**CapX2020  
Hampton – Rochester – La Crosse  
345 kV Transmission Project  
Docket 5-CE-136  
Completeness Response: Item 01-07**

Date of PSCW Request: February 1, 2011

Item 01-07 / Page 2-29, Tables 2.1-1 through 2.1-9 and Appendix L / AFR Section 2.1.2.2

JOB NUMBER	REV
118645	A
DRAWING NUMBER	
S6-7A

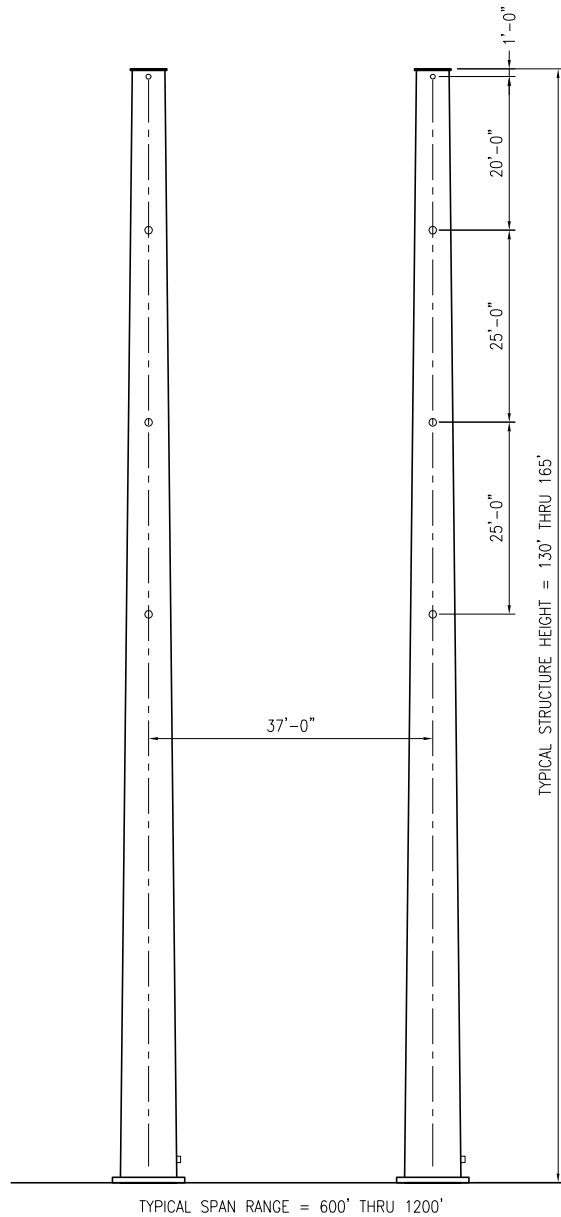
Provide segment ID identification for pole configurations. The pole configuration descriptions in Segment 2.1.2.2, Tables 2.1-1 thru 2.1-9 and the figures in Appendix L do not identify a specific segment.

**Segment to Structure Drawing  
Reference Table added.  
Note added to drawings S6-7A,  
S6-7B, S6-8, S6-9, S6-10A,  
S6-10B, S6-13, S6-15, S6-16  
and S6-32.**

This is a dead end structure.  
Insulators are in-line with conductors and are therefore not shown on the drawing.

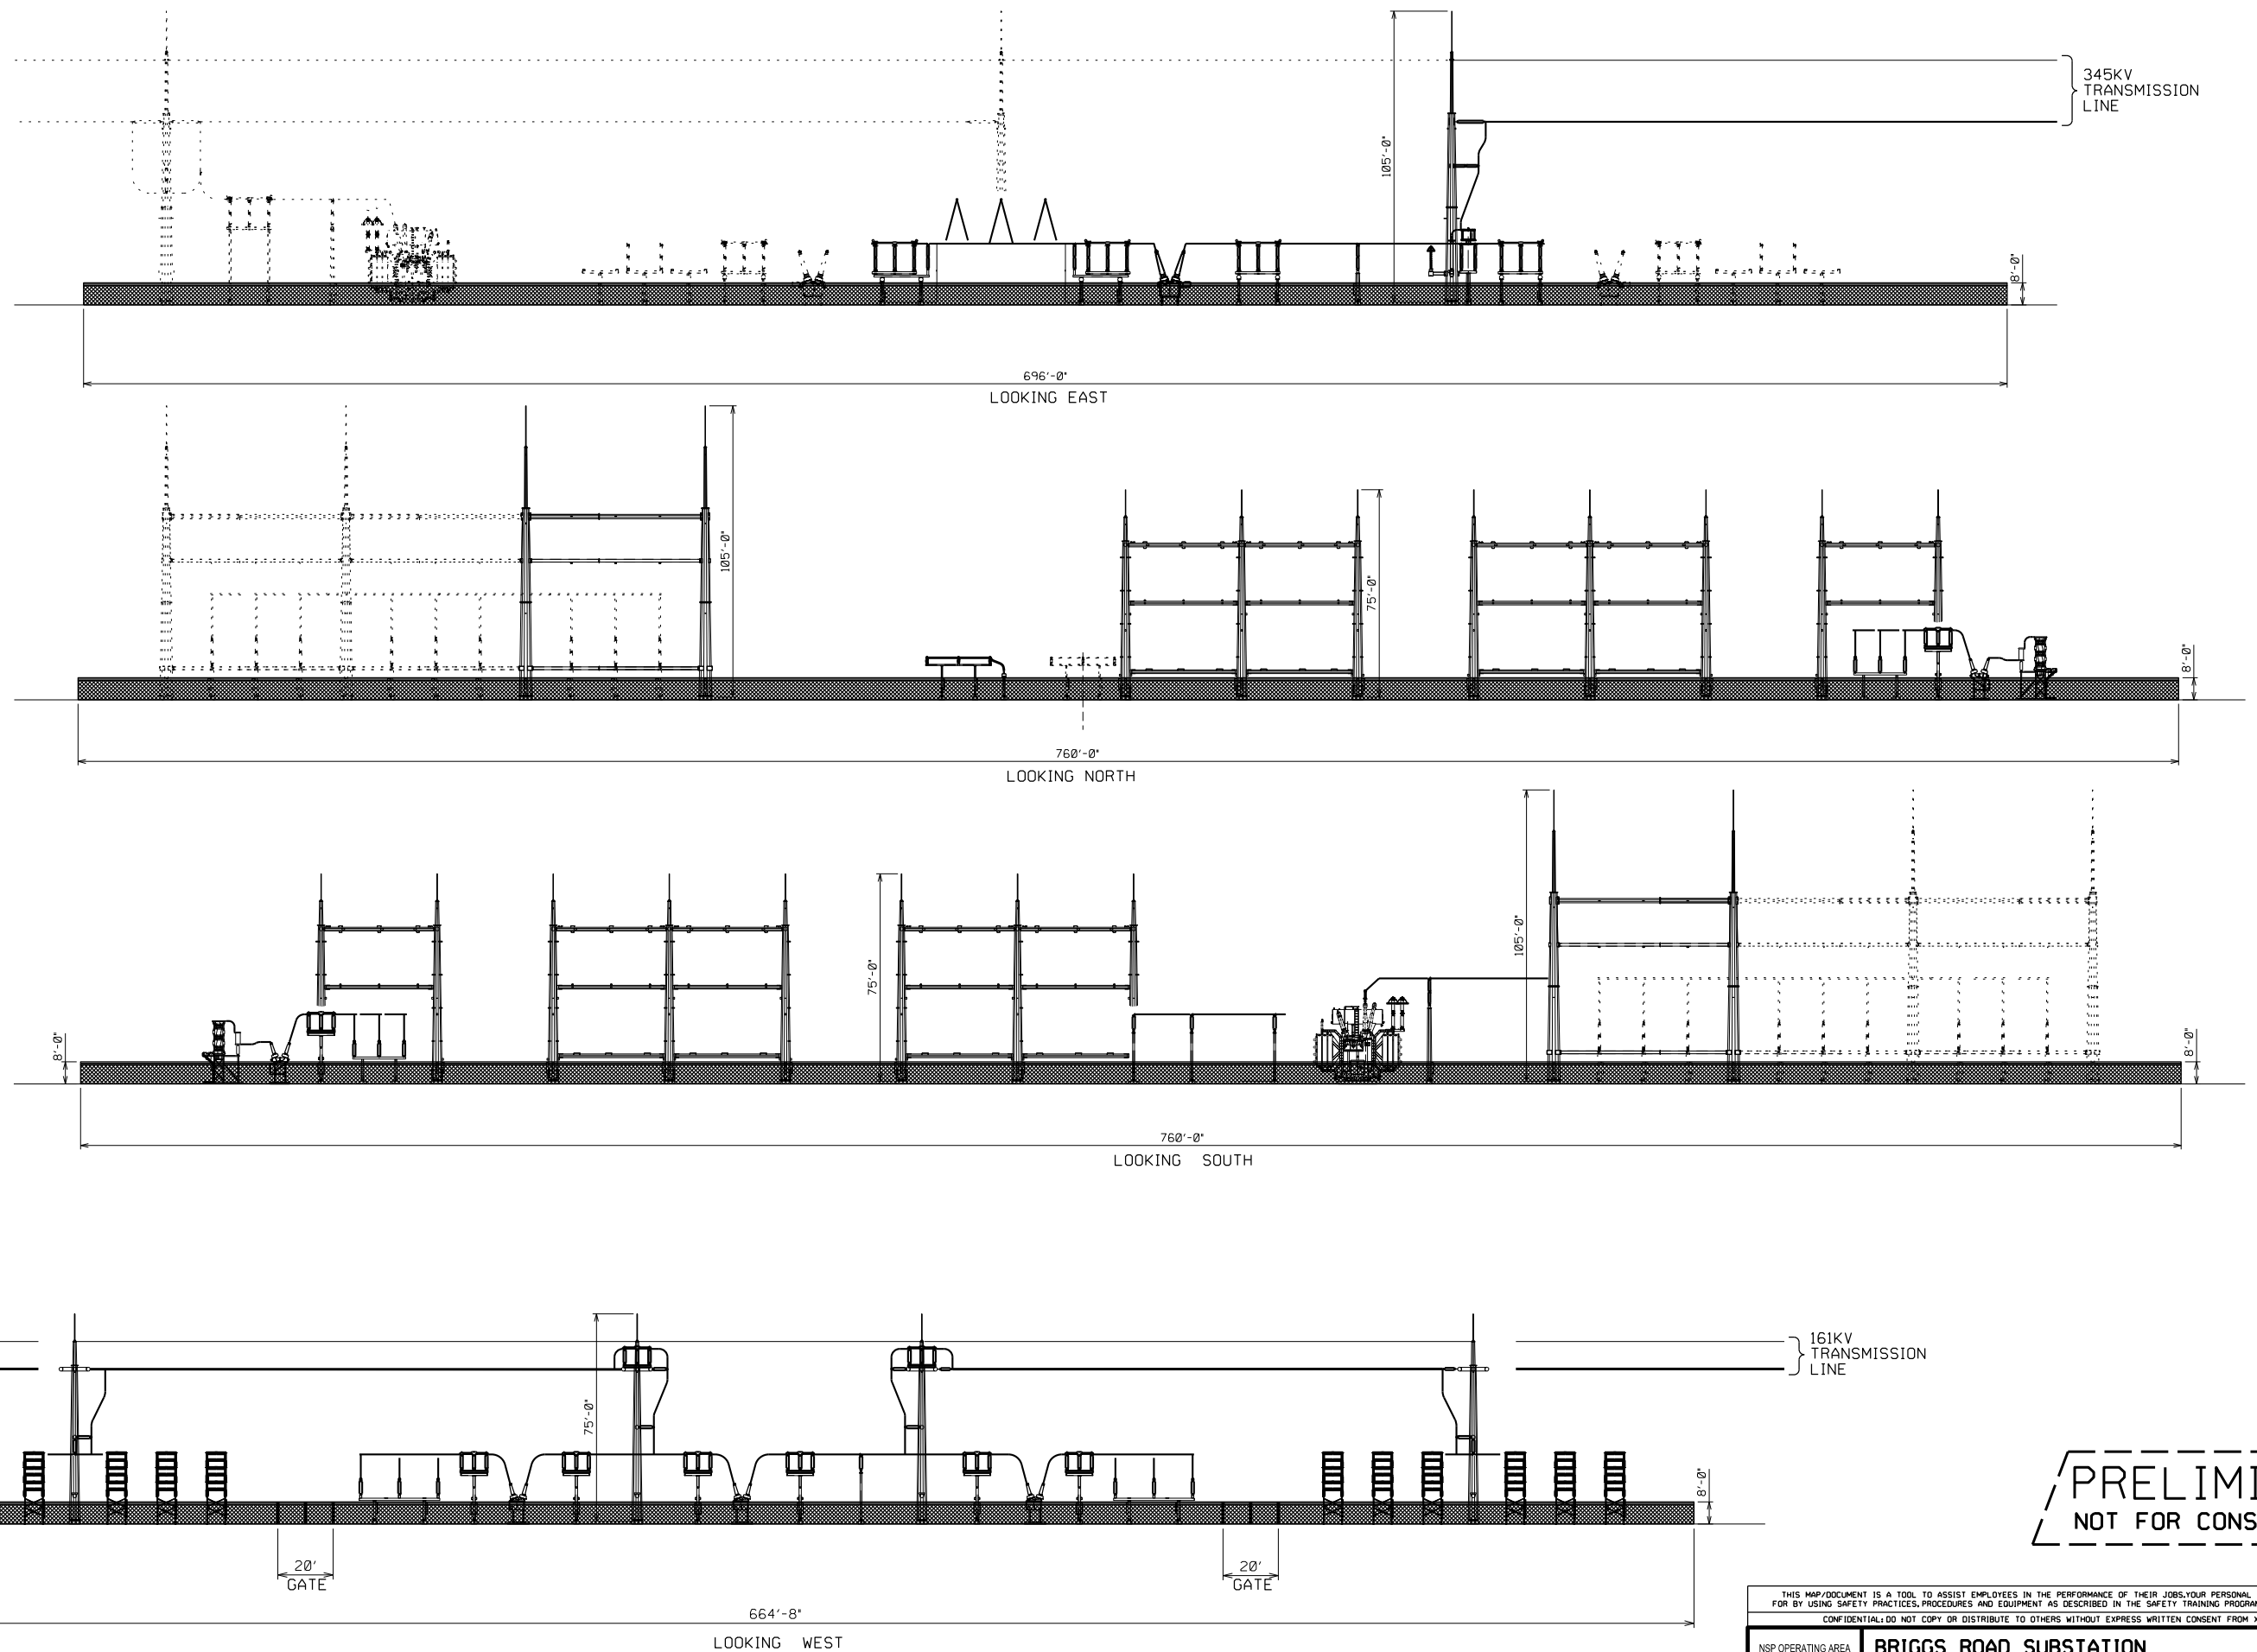
Provide a labeled plan with side and front elevations with dimensions for Figure 1 (Appendix K). Provide vertical dimensions for equipment and provide a diagram(s) showing substation equipment from the side with heights of equipment above ground level. Show proposed equipment in relation to surrounding landscape features.

Response Item 01-12 adds Figure 1A, to be inserted after Figure 1 in Appendix K. The CPCN text has been revised to include a reference to this new figure.
